Historic District Commission

STAFF REPORT

COA-2018-02, Modification #1 - 143 Main Street, Wright House Renovations

Figure 1. Image from the proposed site plan submitted by the applicant, which shows the proposed walkway shaded in dark gray.

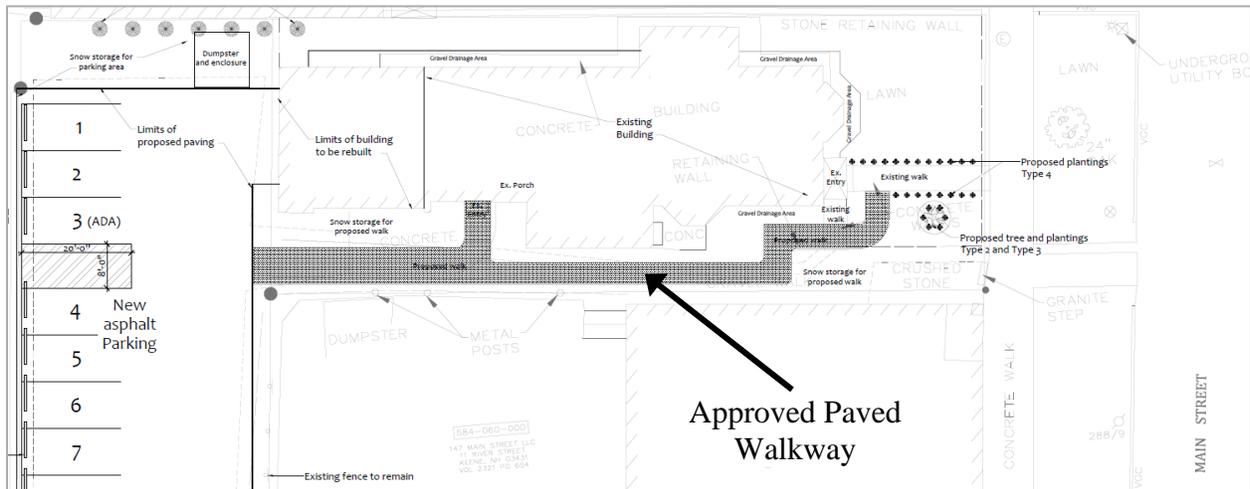
As part of COA-2018-02, the HDC granted approval for the Applicant to install a paved walkway to provide an accessible path of travel from the parking area behind the building to the existing porch entrance on the south façade of the building and the proposed accessible entrance on the east façade of the building (facing Main Street). This pathway would connect to the existing concrete walkway in the front of the building. The existing walkway in front of the building that connects the front entrance to the sidewalk on Main Street would not be removed or relocated. Figure 1 shows an image from the proposed site plan submitted by the Applicant, with the approved new walkway shaded in gray.

With this request, the Applicant proposes to pave the existing parking lot located behind the primary structure. No new driveways or onsite parking are proposed; however, the existing curb cut on Davis Street would be narrowed from roughly 40 feet to about 25 feet in width. While the Applicant has not submitted drainage calculations to demonstrate that there will be no increase in water runoff onto adjacent properties, the Applicant is aware that they will be required to submit drainage calculations prepared by an engineer when they seek site plan approval for this project from the Planning Board. The HDC standards for driveways and parking areas appear to be met.

Figure 3. Photo from the City of Keene Assessing Department of the existing barn on the 143 Main Street property, taken from Davis Street. The pre-existing door opening where a new door is proposed is circled in red.

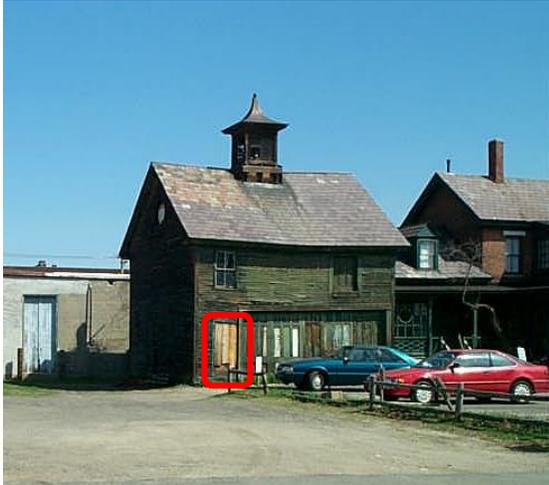
The current proposal is to save the existing barn, which would require major structural repairs including pouring a new foundation, installing steel framing to hold up the structure, and replacing existing damaged vinyl siding with new clapboard siding. In addition, the Applicant requests the installation of an egress door in a pre-existing door opening on the south façade of the barn and a garage door on the west façade of the barn. The Applicant also proposes to replace the existing slate roof with an asphalt roof, and use the slate from the barn to repair the slate on the roof of the primary building. Figure 3 shows an image of the existing barn before it was clad in vinyl siding, with the proposed location for a new door circled in red. Figure 4 shows an image of the existing barn as it appeared in 2018, after vinyl siding was added that covers up

In addition to the work that was previously approved, the applicant proposes to replace the existing vinyl siding on the barn with clapboard siding that would be painted white. Historically, the barn was clad in wood clapboard siding, as shown in Figure 4. This request appears to meet the HDC standards for wood siding.
